TRACTION CONTROL LAMP ON—NO DTCS PRESENT, OR DTC P1889 IN DIFFERENTIAL ELECTRONIC MODULE (DEM)

TSB 08-4-11

2005-2007 Five Hundred, Freestyle

This article supersedes TSB **06-6-3** to update the symptom and the Service Procedure.

Figure 1 - Article 08-4-11

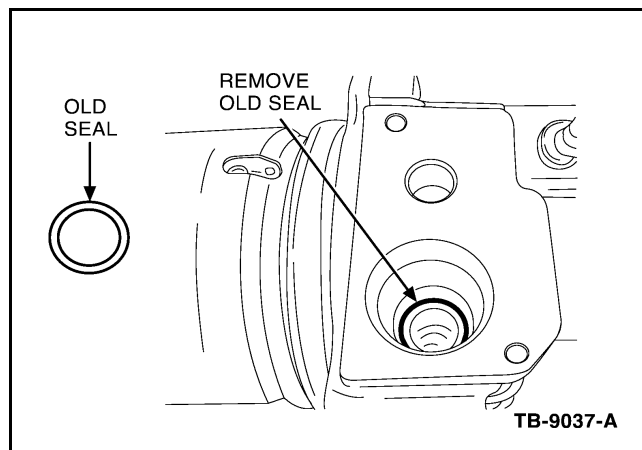
4. Remove the existing O-ring from the coupling body. (Figure 1)

Figure 2 - Article 08-4-11

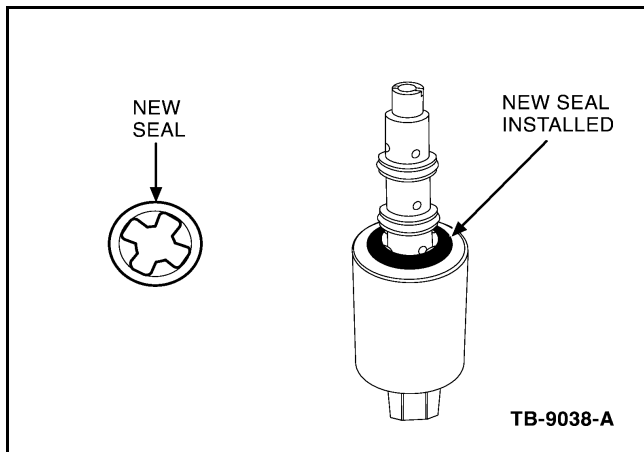
5. Install the new O-ring included in the Pressure Sensor Kit, on the solenoid valve. (Figure 2)
